Stage 04: Code Administrator Consultation

CMP213 Project TransmiT TNUoS Developments

Consultation Responses

Annex - the linearity of the relationship between load factor and incremental constraint costs

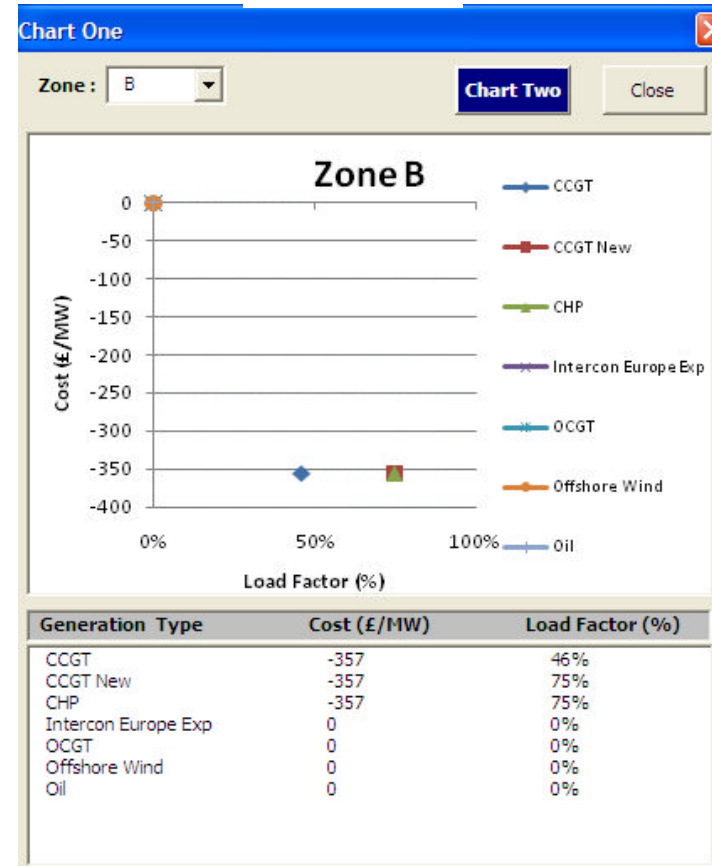
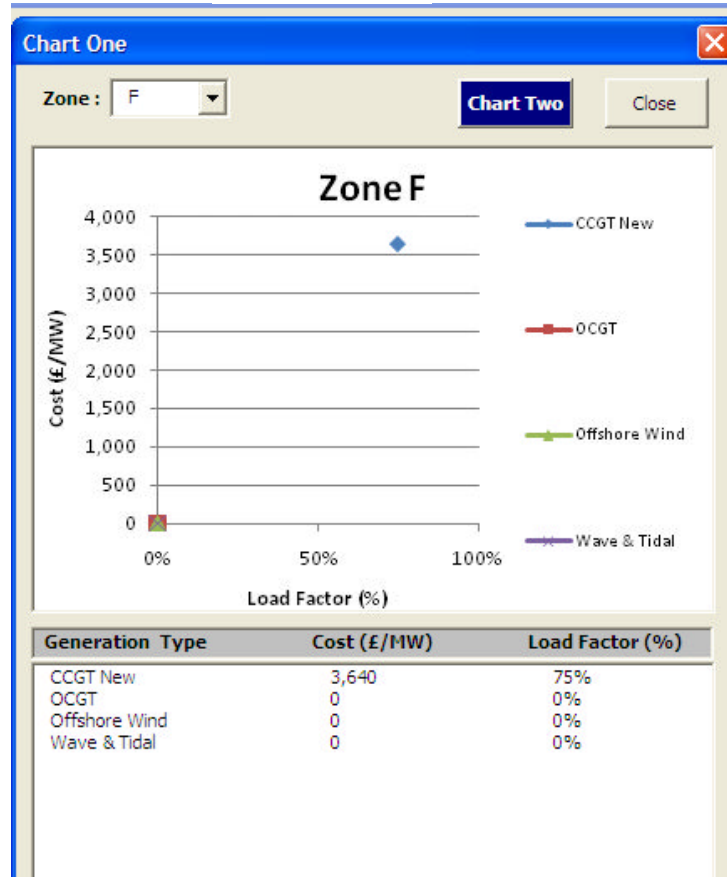
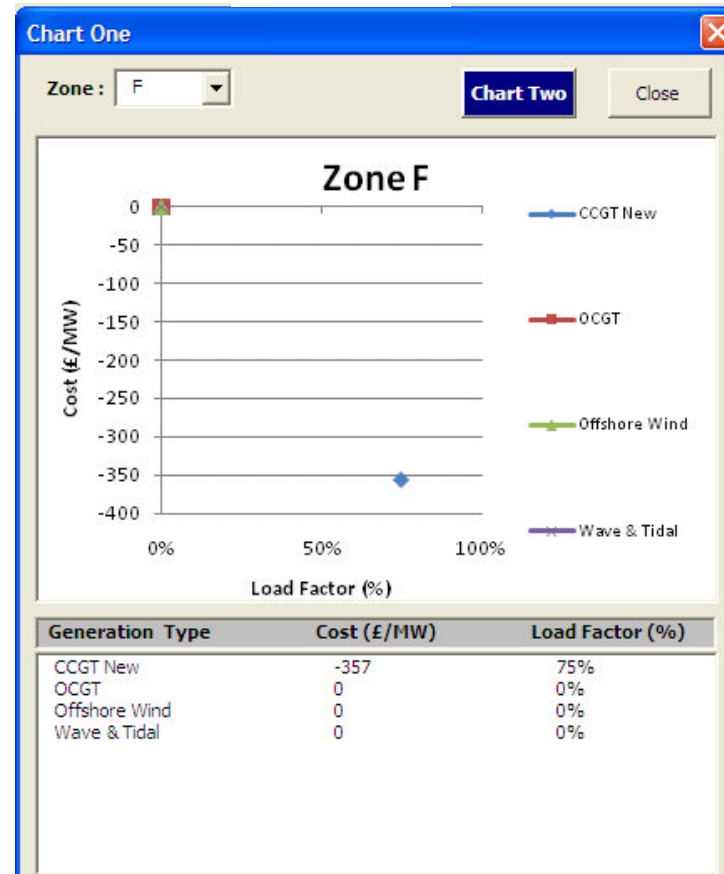
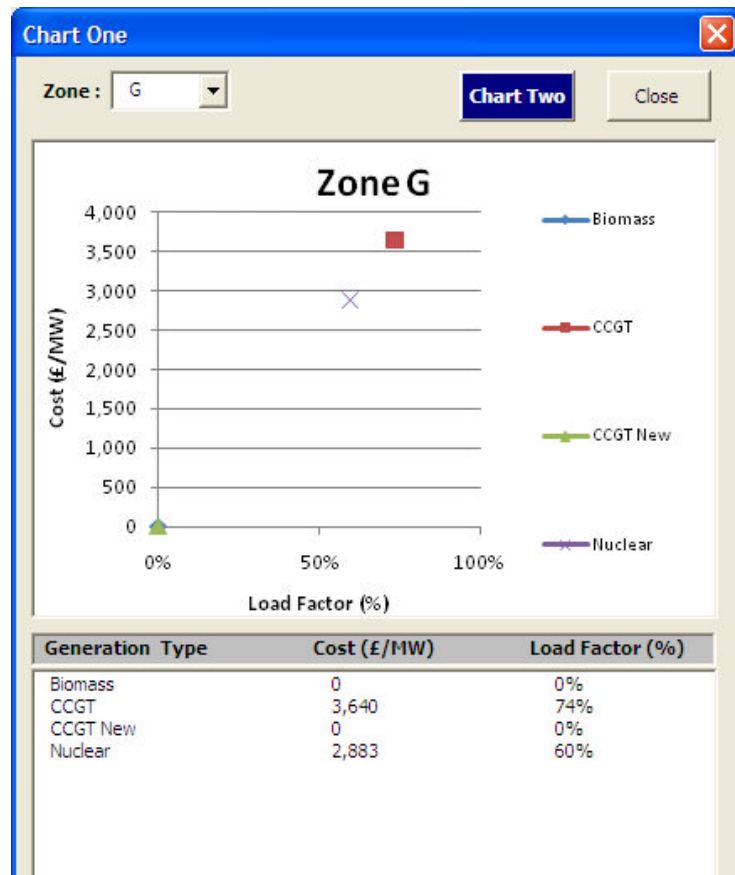
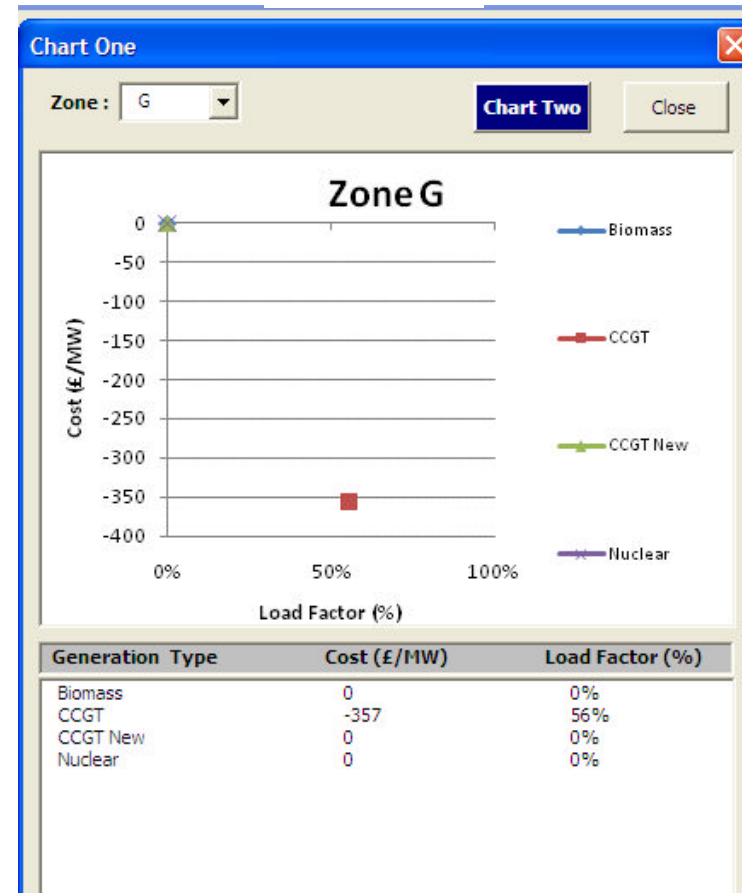
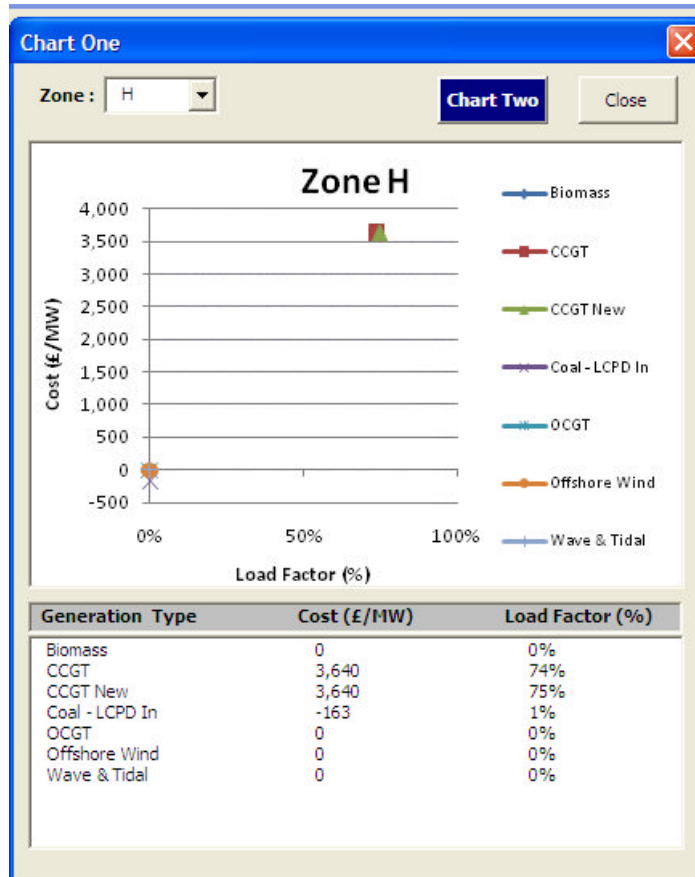
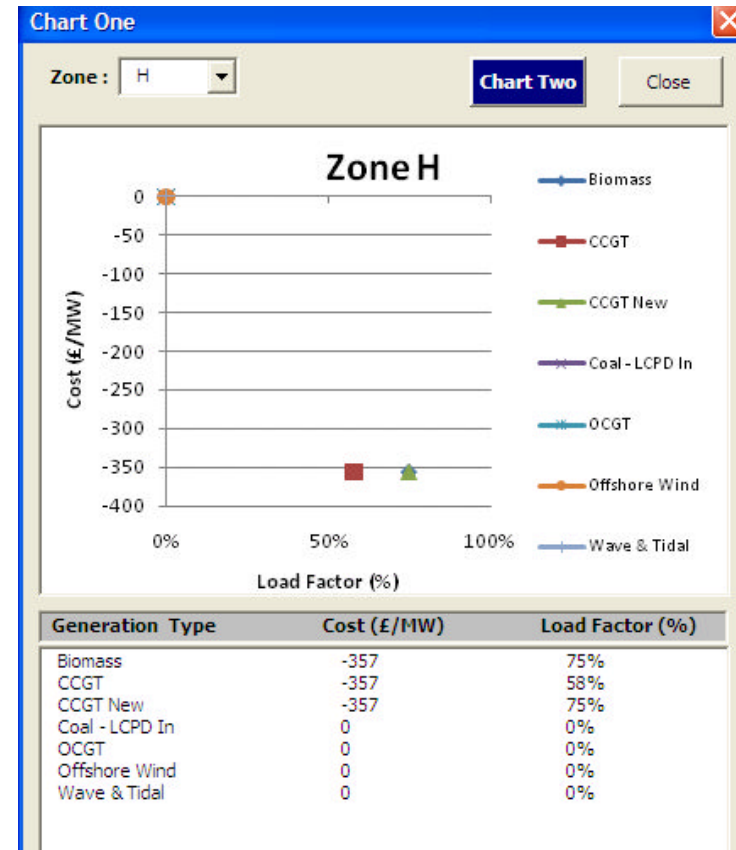
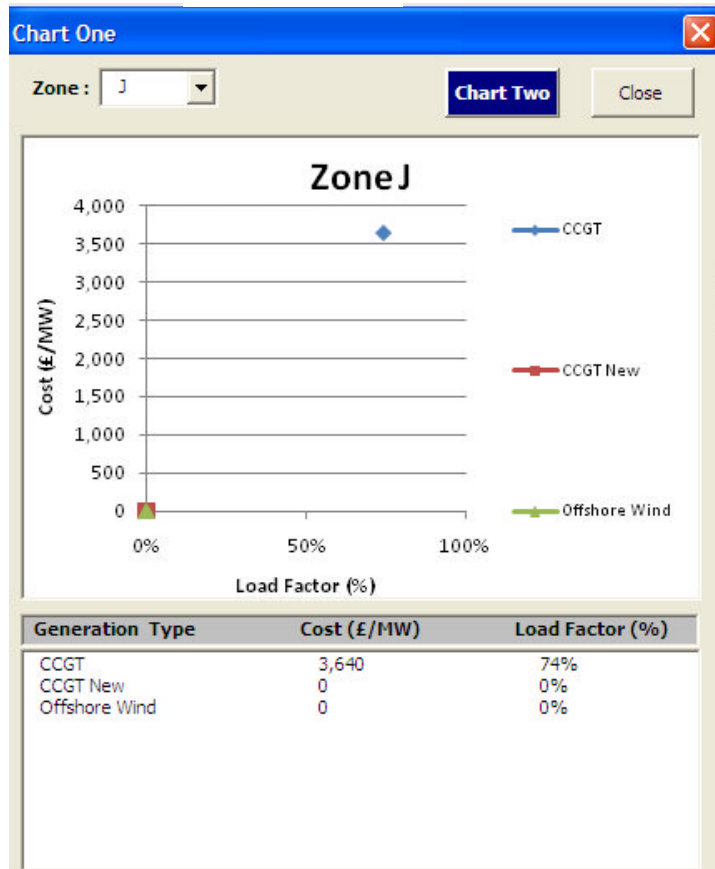
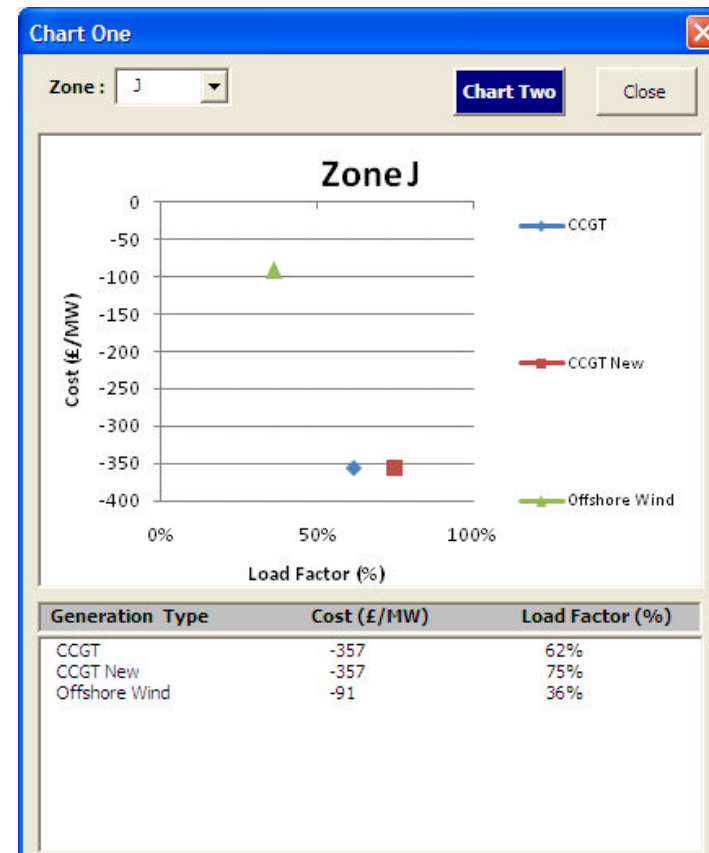
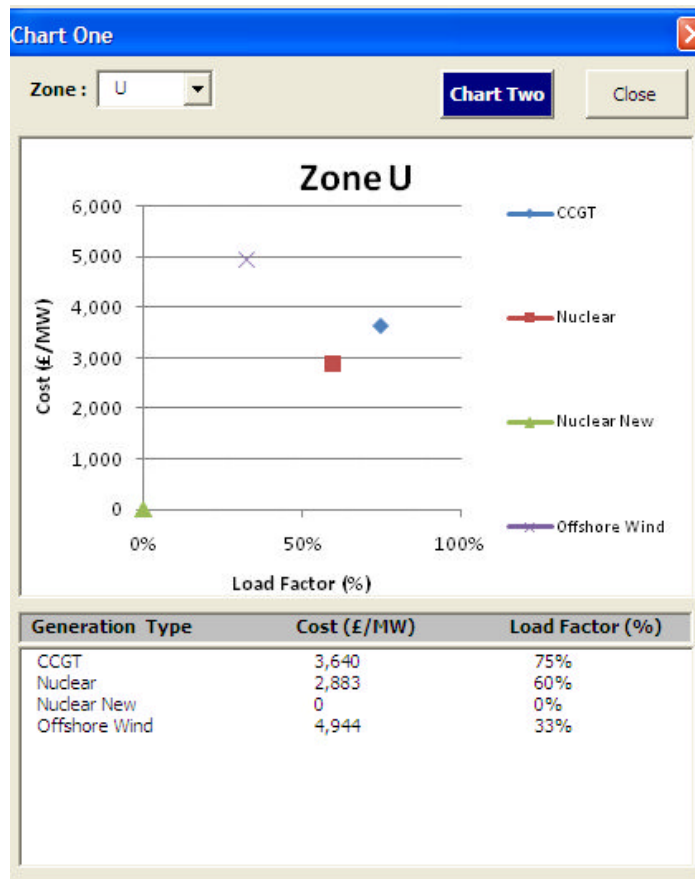
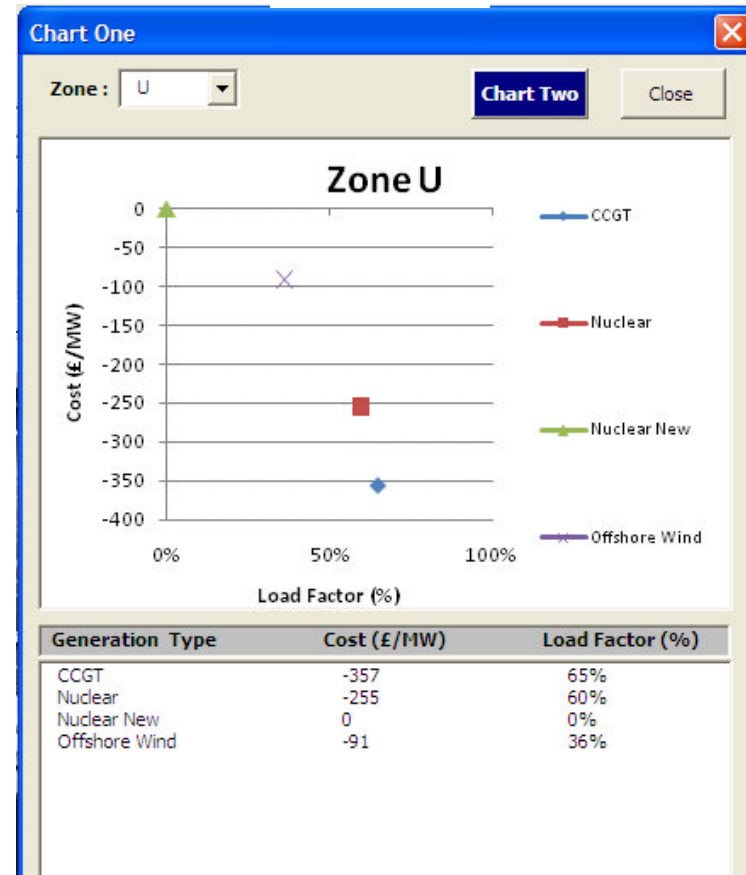
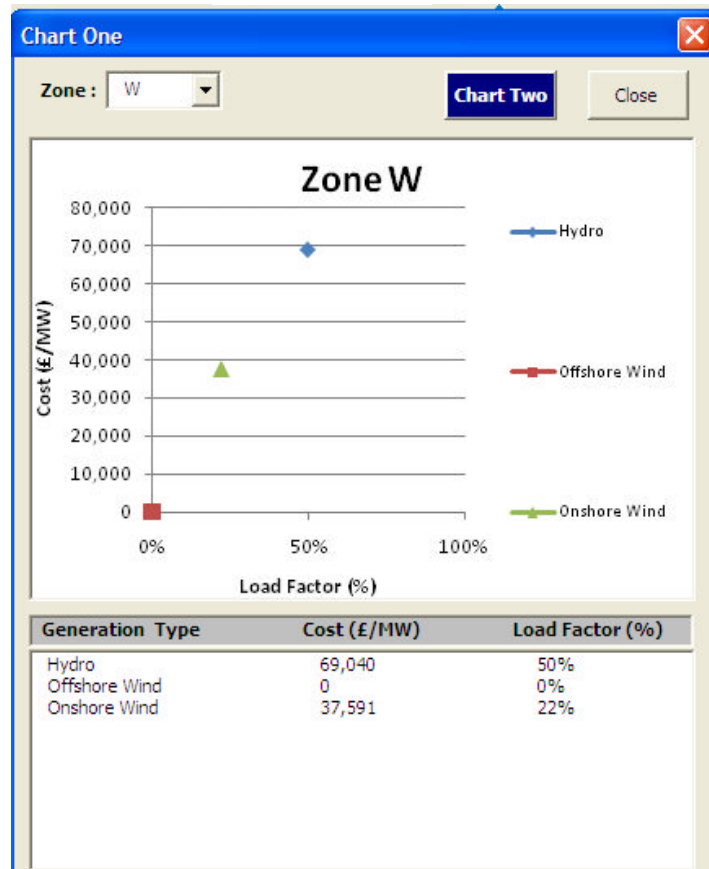
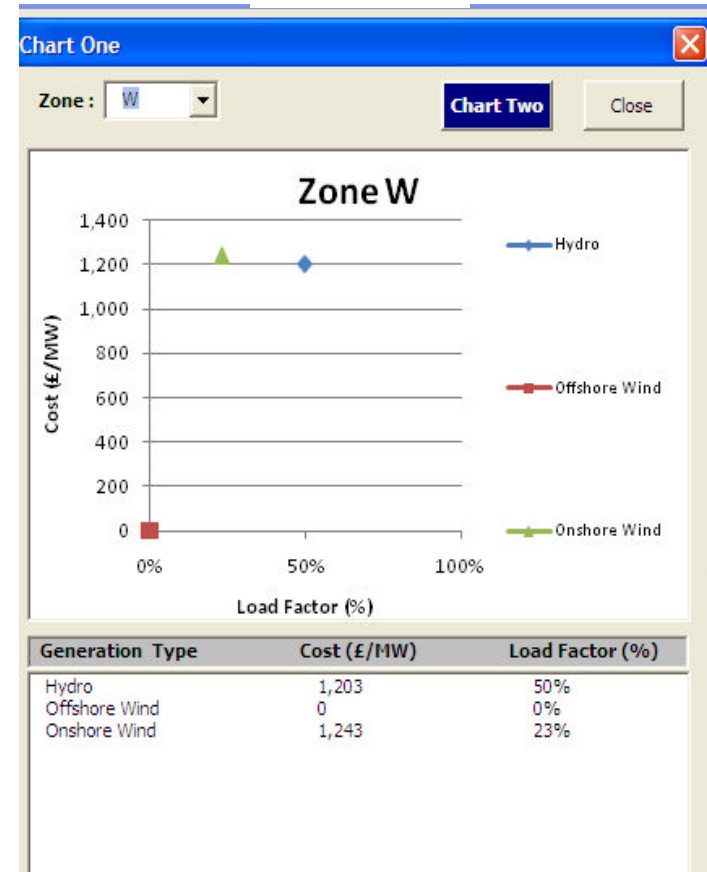
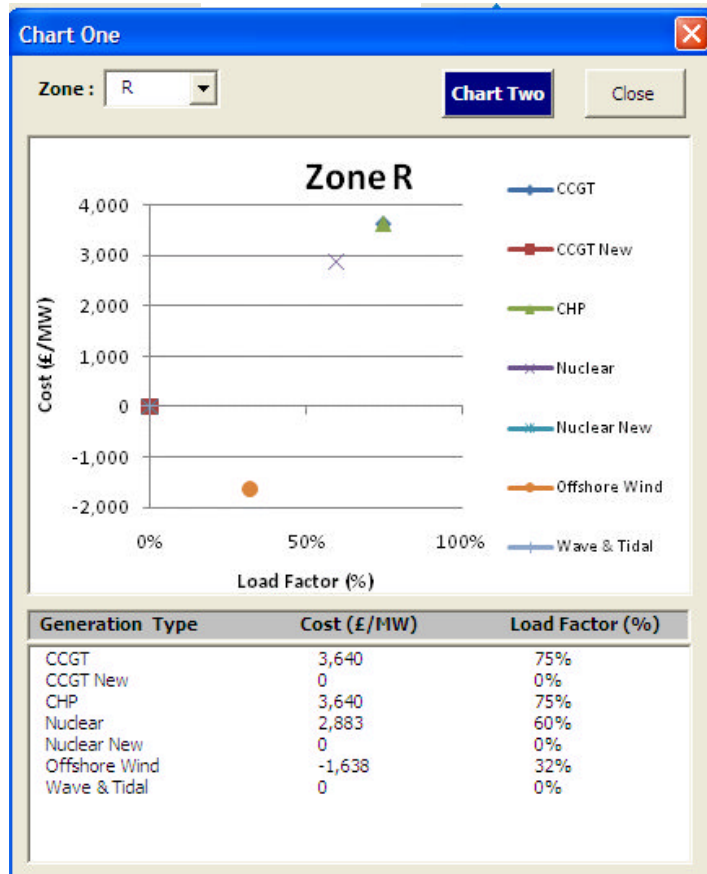
The evidence which is used to demonstrate this linearity is typically based on a 2011/12 generation background (inc. that on pages 176 to 179 of the workgroup consultation document). Analysis undertaken by Centrica using the ELSI model using 2015/16 input data (including boundary capacity data from the Seven Year Statement) show no distinguishable linearity between load factor and constraint costs in the majority of zones (please see the annex). Examining the relationship between load factor and incremental constraint costs the ELSI model produces on a 2015/16 background is important because it is, for obvious reasons, a more relevant time period than 2011/12. The breakdown of any perceivable relationship by 2015 should be examined by the Working Group.
